These are additional comments (**brown font**), after the PSC final letter (dated 13 June 2019) was sent to me.

The North Dakota Public Service Commission (Commission) has reviewed your filing, dated May 15, 2019, regarding your land located in the NW¼ of Section 34, T146N, R88W.

Complaint No. 1: *Constructed a diversion ditch on farmland creating a new affected area outside the permit area without a PSC permit revision and without Landowner consent, no associated reclamation plan or performance bond, and resulted in loss of crop income.*

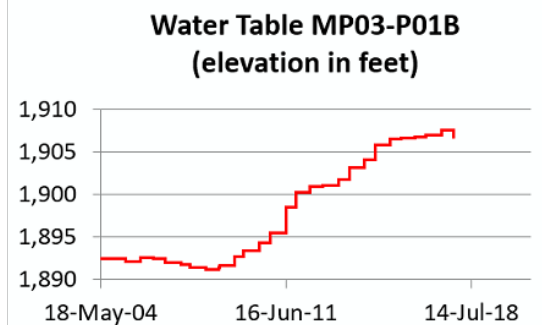
For proof, look at the increase in water table elevation increases a half mile south of the farmland (the opposite direction of Lake Sakakawea) beginning in 2011.
